**CITY OF ALLENTOWN
HISTORIC ARCHITECTURAL REVIEW BOARD
FINAL REVIEW SHEET
May 7, 2018**

Case #HDC-2018-00021 – Proposal to rehab/restore the façade

Property located at: 726 Gordon St.

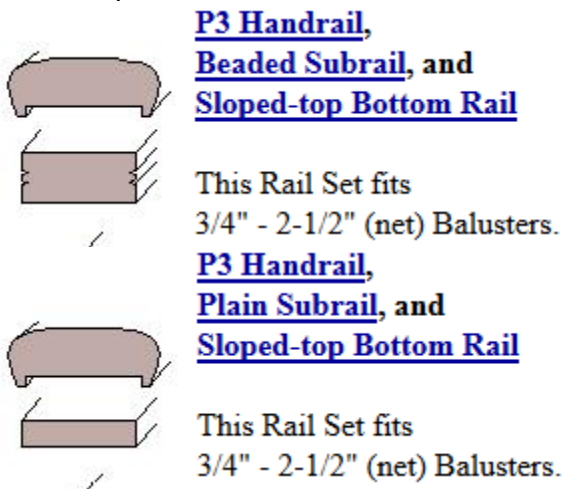
- Rear porch: Typically a heavier top rail with turned balusters would be expected, however given that the historic railing has long been gone, a more simplified version would be acceptable (see profiles following list). Balusters could be turned or straight, but in either case they should be at least 2" to 2 1/2" square/turned. New wood work should be primed and painted.

6. The inappropriate balusters on rear porch will be replaced with historically appropriate turned balusters with traditional top and bottom rails.
7. The existing satellite dishes will be removed.
